DEPARTMENT OF TRANSPORTATION**DIVISION OF ENGINEERING SERVICES**

Contract #: 04-0120F4Cty: SF/ALA Rte: 80 PM: 13.2/13.9File #: 69.28**WELDING INSPECTION REPORT****Resident Engineer:**Pursell, Gary**Address:** 333 Burma Road**City:** Oakland, CA 94607**Report No:** WIR-001028**Date Inspected:** 17-Dec-2007**Project Name:** SAS Superstructure**OSM Arrival Time:** 630**Prime Contractor:** American Bridge/Fluor Enterprises, a JV**OSM Departure Time:** 1530**Contractor:** Zhenhua Port Machinery Company, Ltd (ZPMC), Changxing Island **Location:** Shanghai, China

CWI Name:	N/A	CWI Present:	Yes	No			
Inspected CWI report:	Yes	No	N/A	Rod Oven in Use:	Yes	No	N/A
Electrode to specification:	Yes	No	N/A	Weld Procedures Followed:	Yes	No	N/A
Qualified Welders:	Yes	No	N/A	Verified Joint Fit-up:	Yes	No	N/A
Approved Drawings:	Yes	No	N/A	Approved WPS:	Yes	No	N/A
				Delayed / Cancelled:	Yes	No	N/A
Bridge No:	34-0006	Component:	114m Mock-ups, 89m Skin's E and D

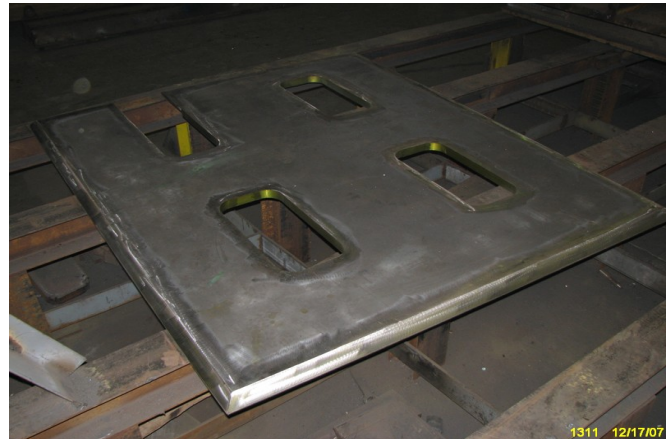
114m lower- Welder is having difficulty making the start of his weld onto the run-off tab. Due to the temporary diaphragm being recessed 50mm into the interior of the mock-up, the welder is sticking his FCAW welding tip out through an access hole at the weld joint. He has extensive stick-out and is out of position from what appeared to be

100-20mm out at the start of this Complete Joint Penetration (CJP) weld.
